Subject: Crystal River Unit 3
Docket No. 50-302
Operating License No. DPR-72
Environmental Protection Agency 316 Study

NOTES OF CONFERENCE
THIRD QUARTERLY PROGRESS MEETING
FLORIDA POWER CORPORATION

Enclosed is a copy of the Notes of Conference from the Third Quarterly Progress Meeting for the Crystal River 316 Study held in St. Petersburg on May 3, 1984.

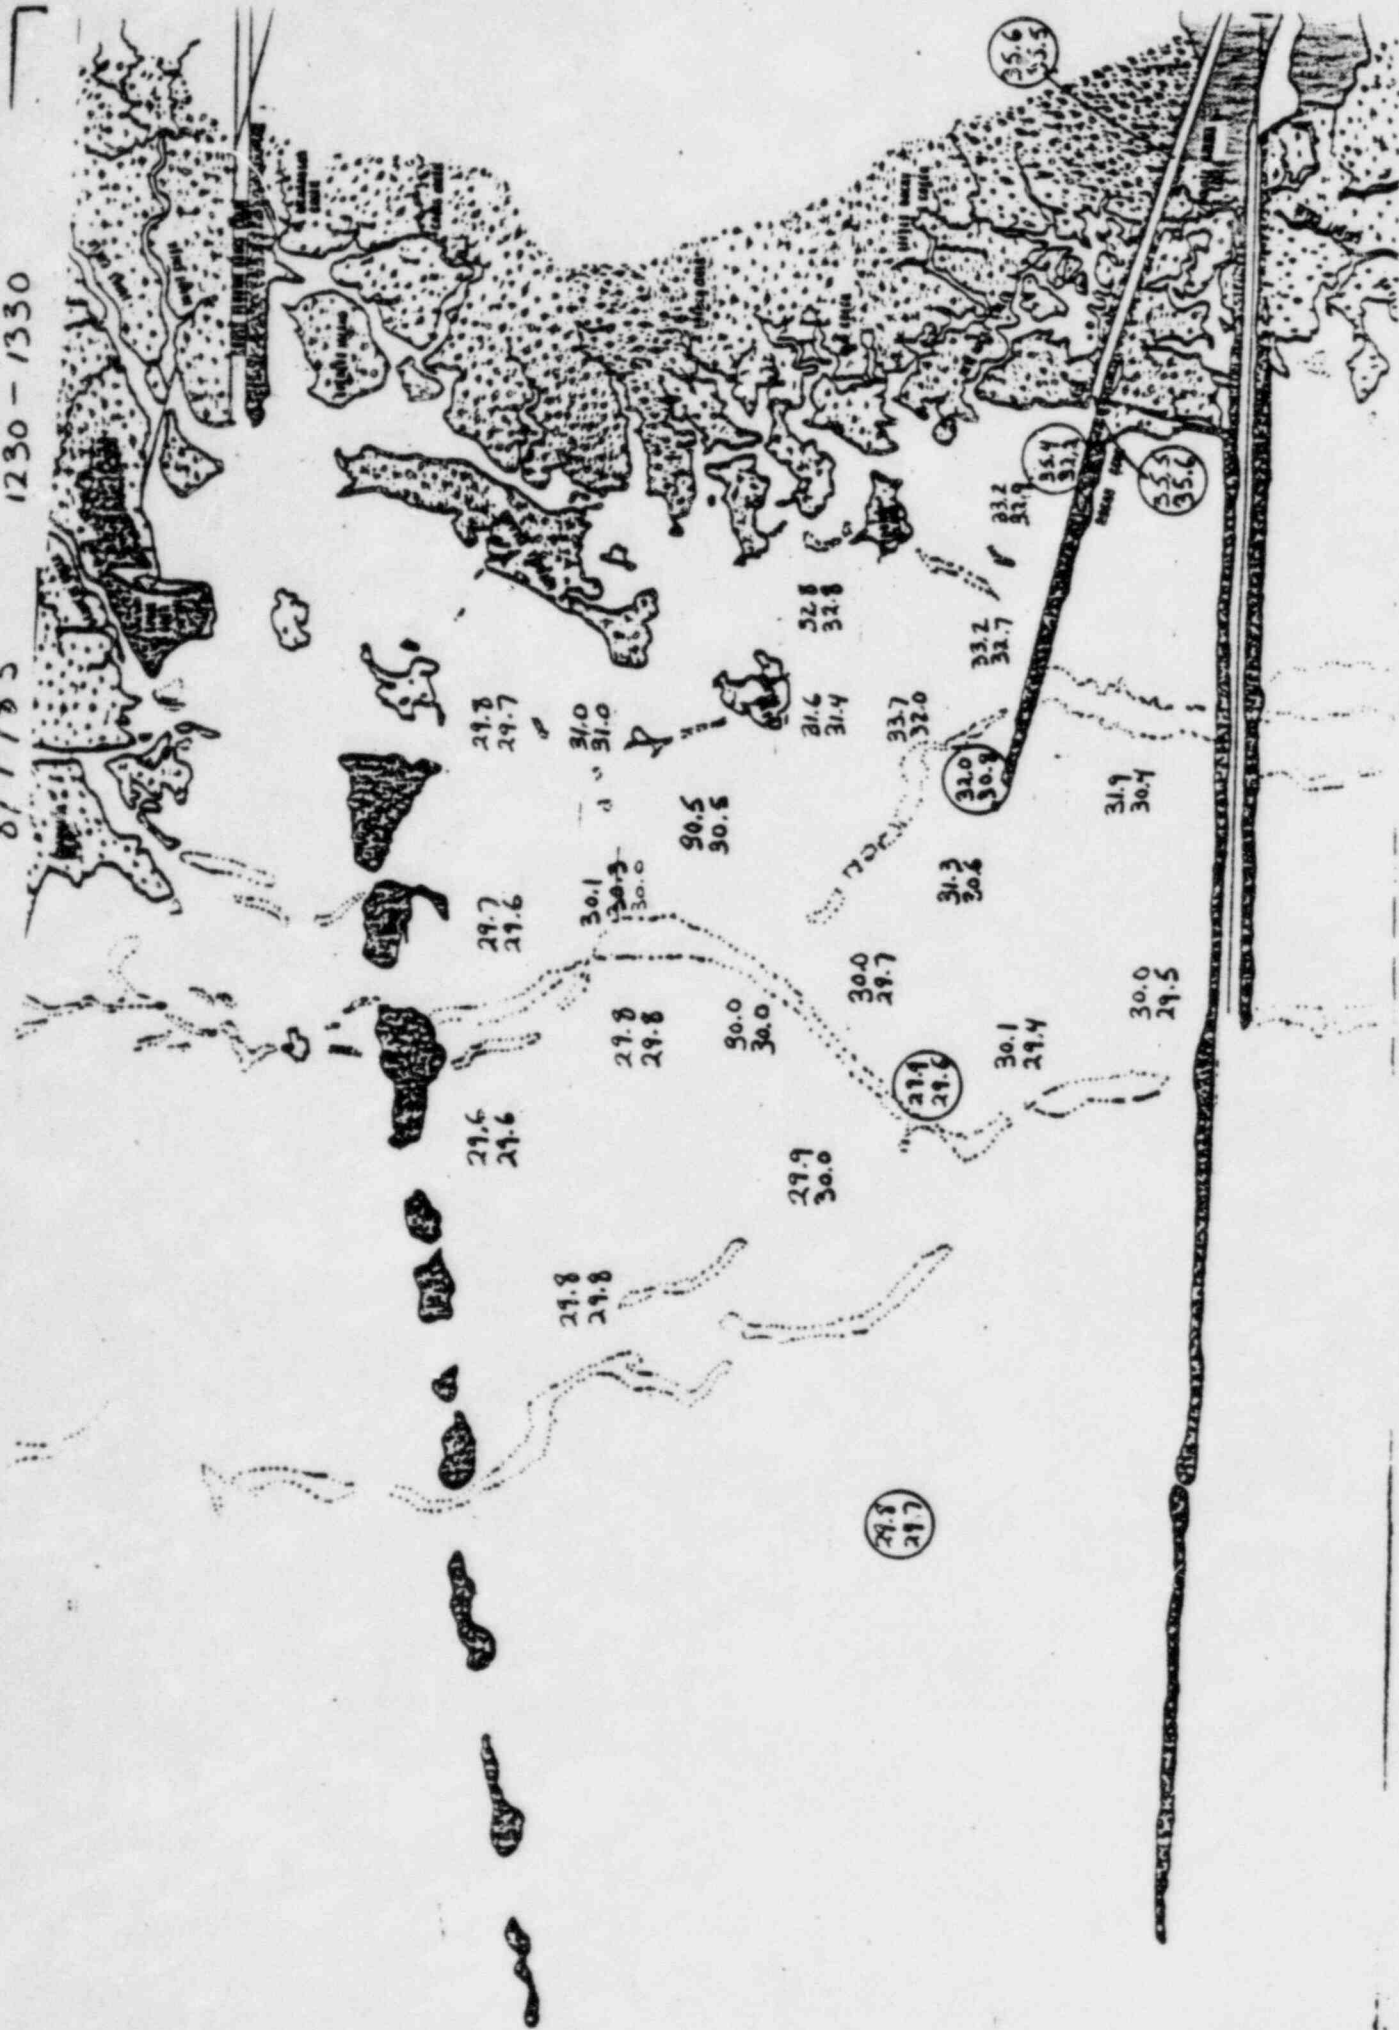
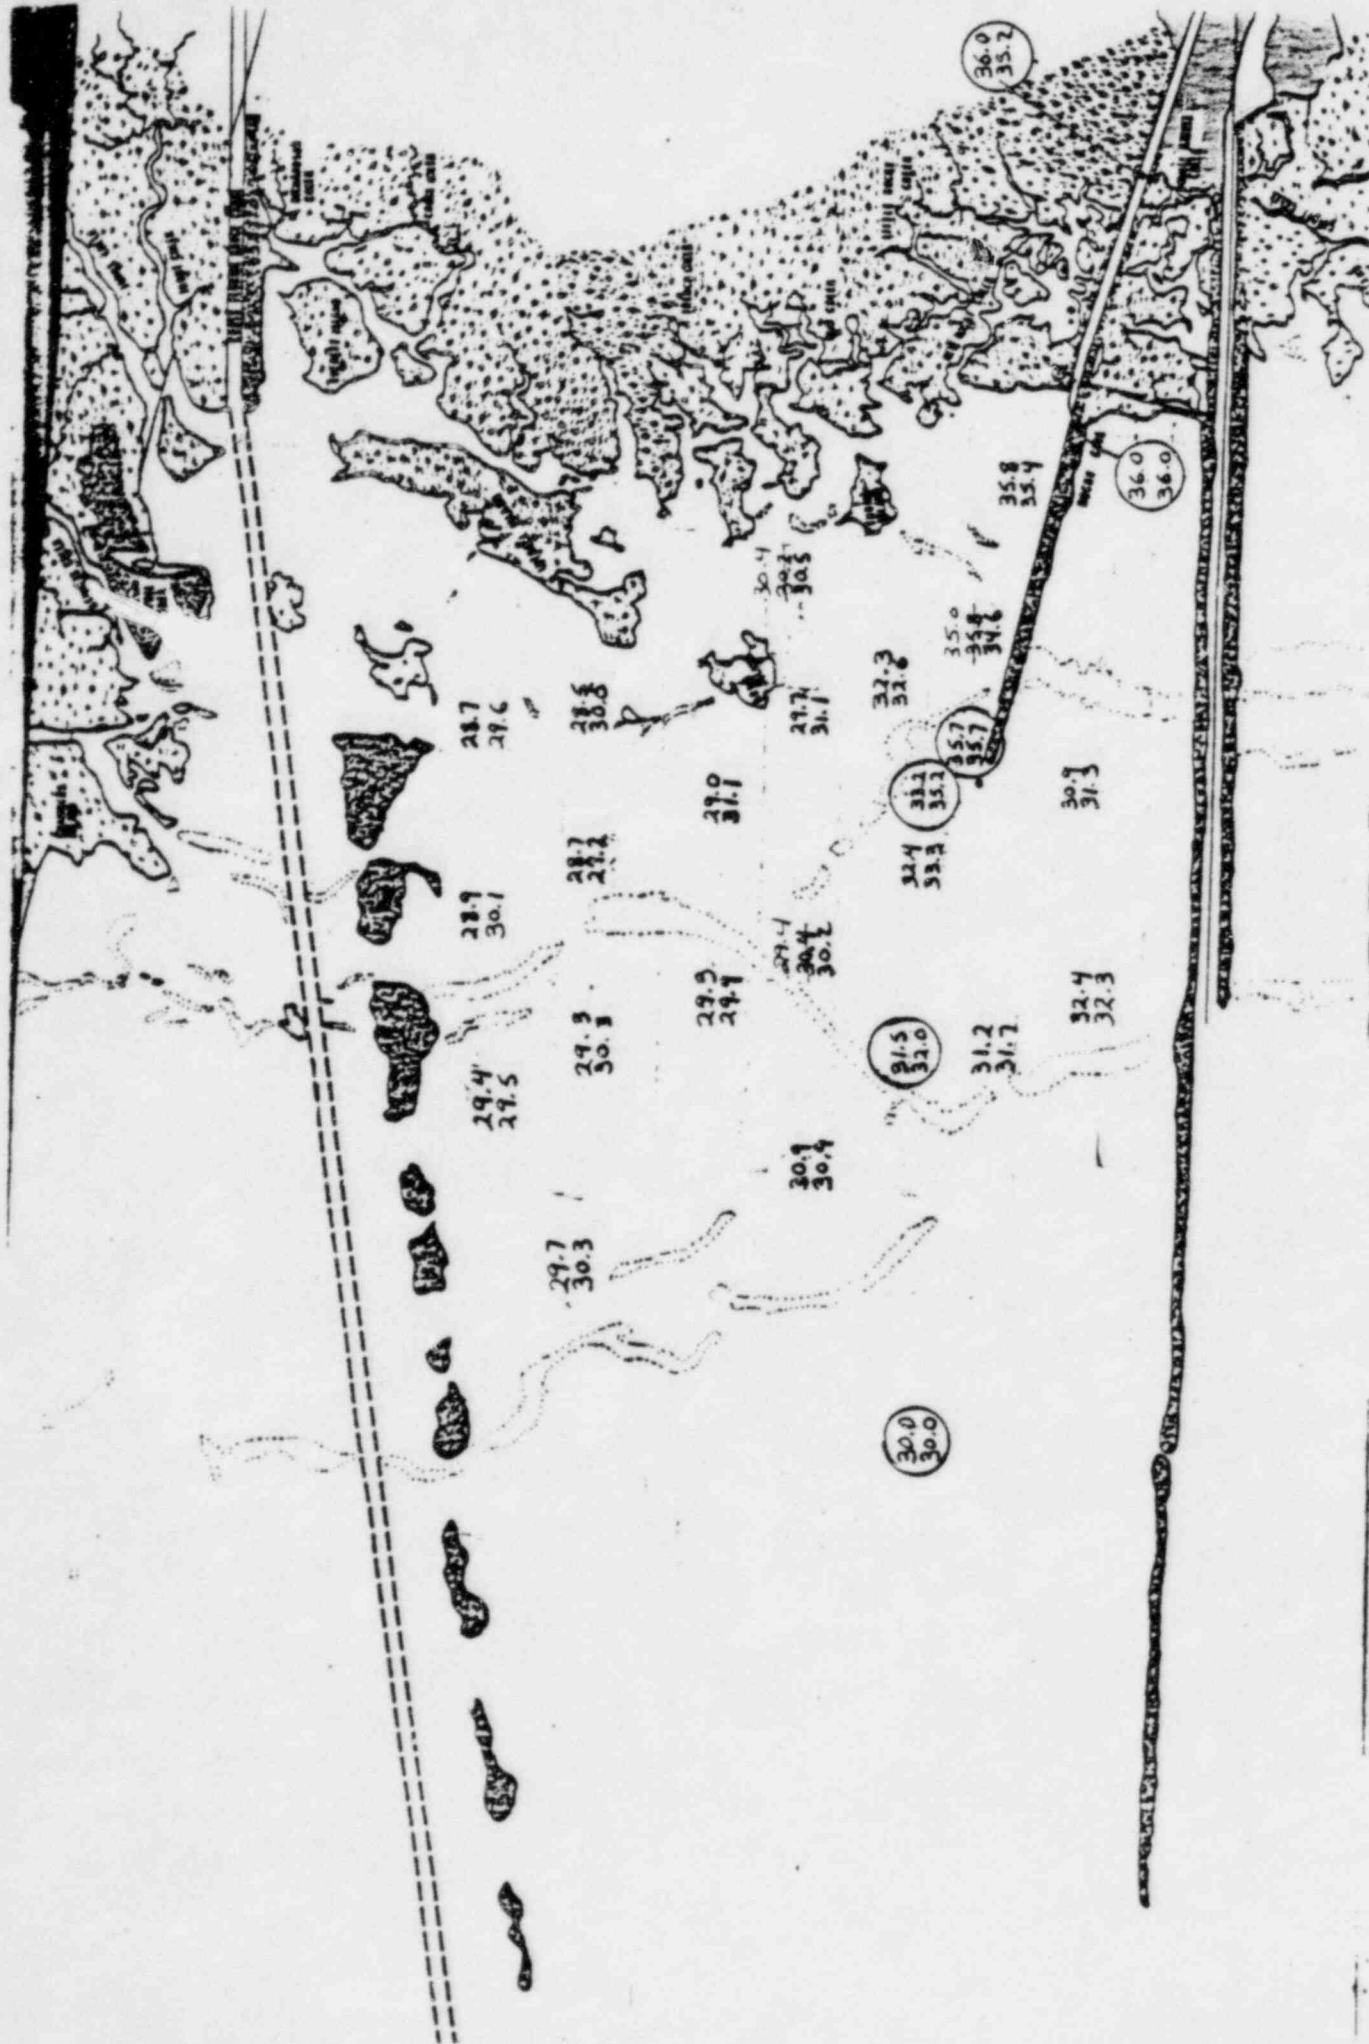
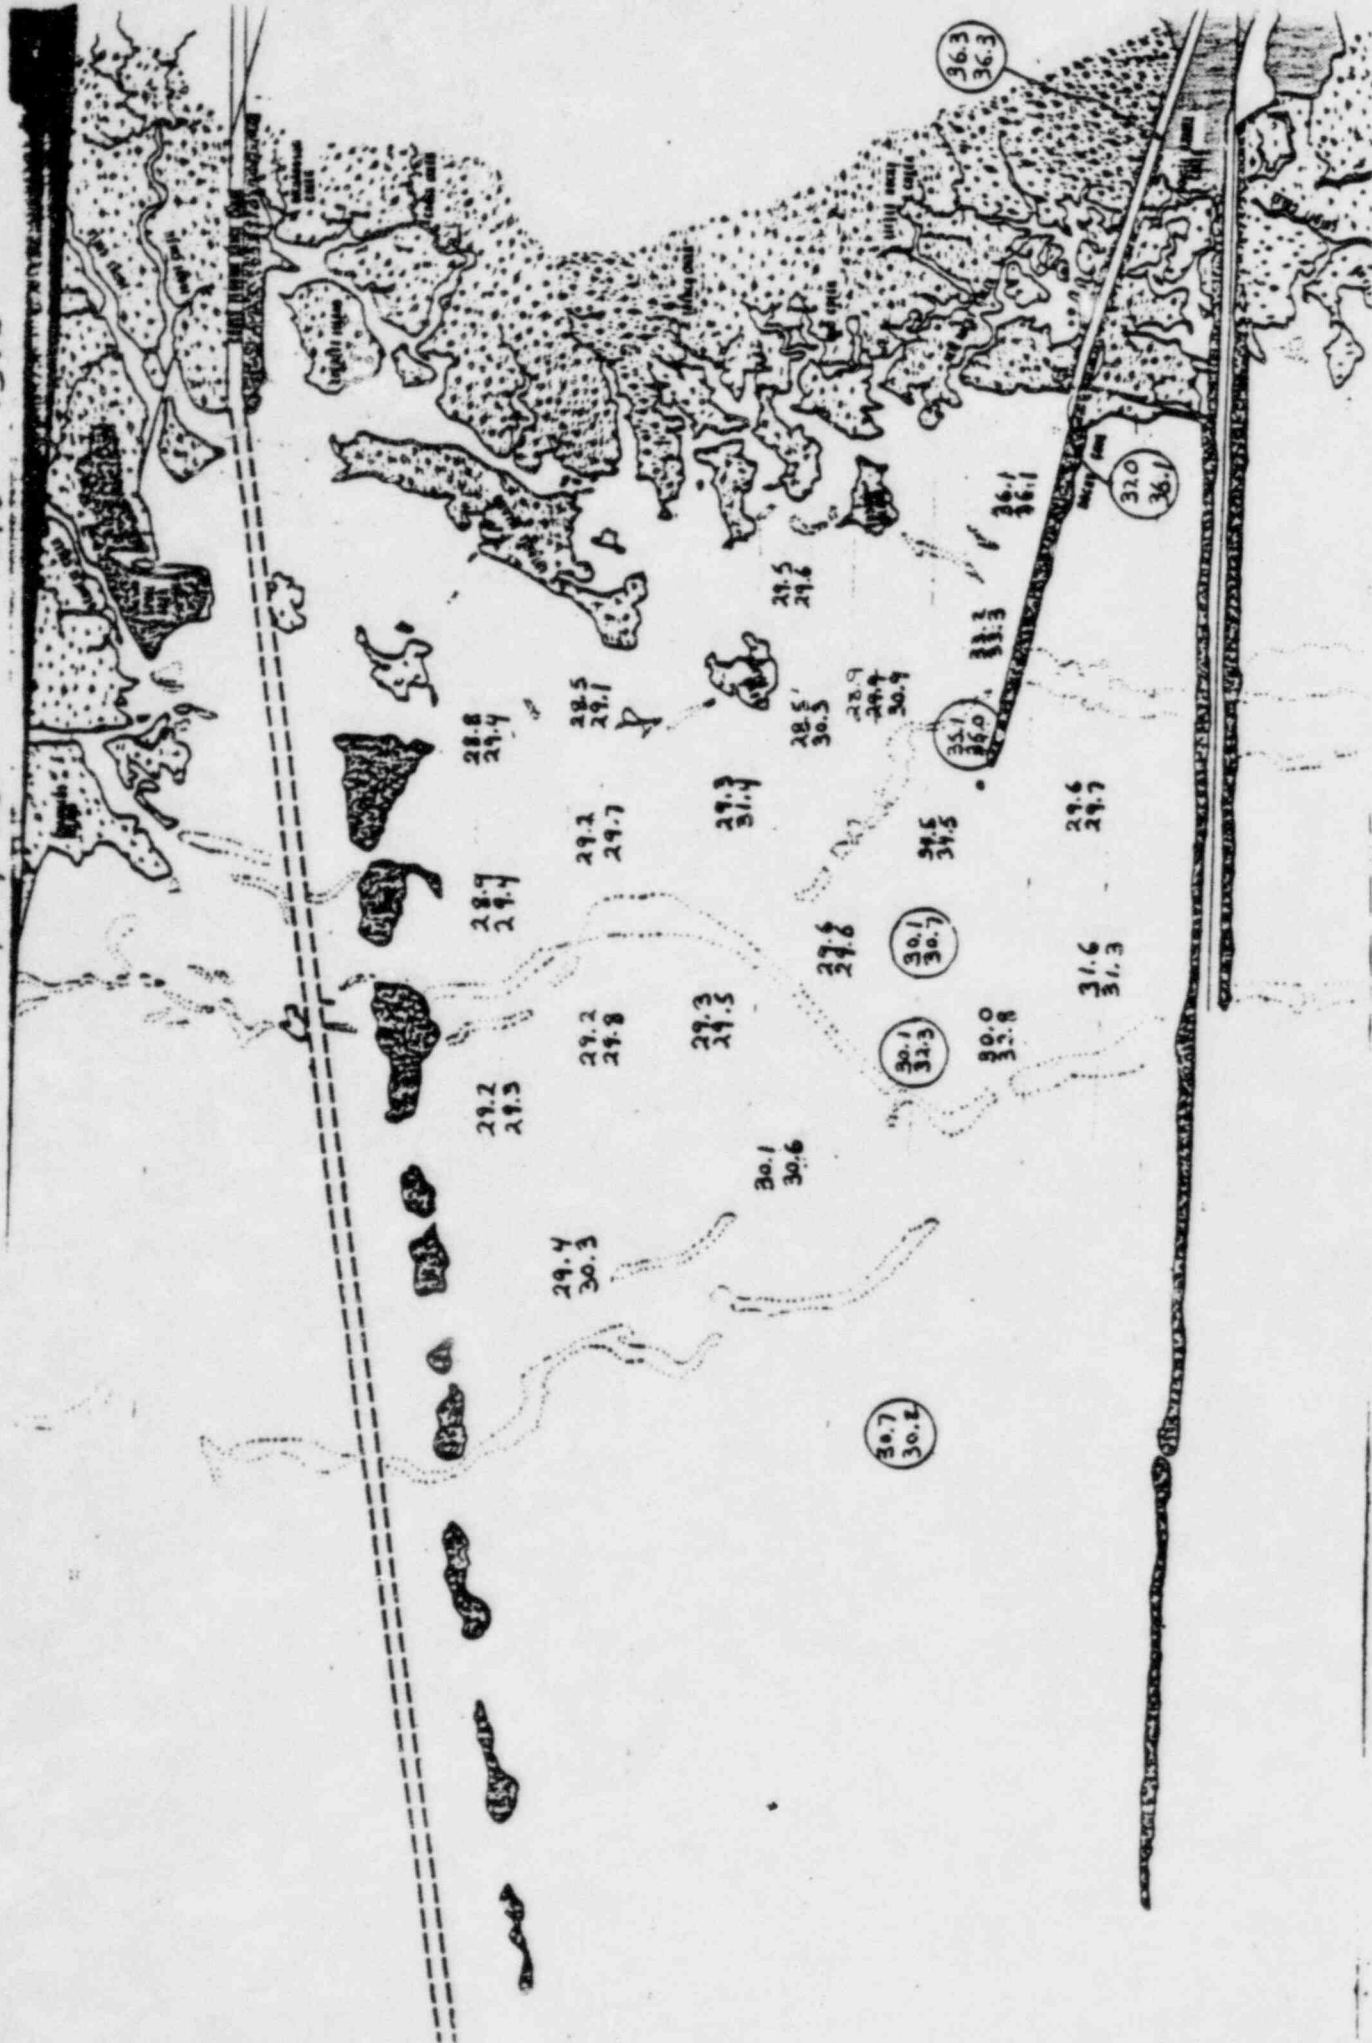
+ no. checks in the field log

* No. is correct based on field log, however a +5° reading error could exist in one measurement. the bottom value then becomes 31.7

- Revised tables of June temperature and conductivity. These tables have been changed to reflect a 90 minute, rather than a 2 hour, tide window and to correct incorrectly specified times for maximum tide.
- July, 1984, temperatures by week.
- Juncus marsh data for October, 1983.
- Entrainment densities for July 21, August 31 (2), September 14, and September 27.
- Fourteen figures showing temperatures monitored in August and January. Also, please note that a few uncircled temperatures have been found to represent single readings in contrast to the absolute statement on Page 4-1 of the Quarterly Report, however, they remain uncircled to distinguish the readings from ones taken by the "chase" boat.
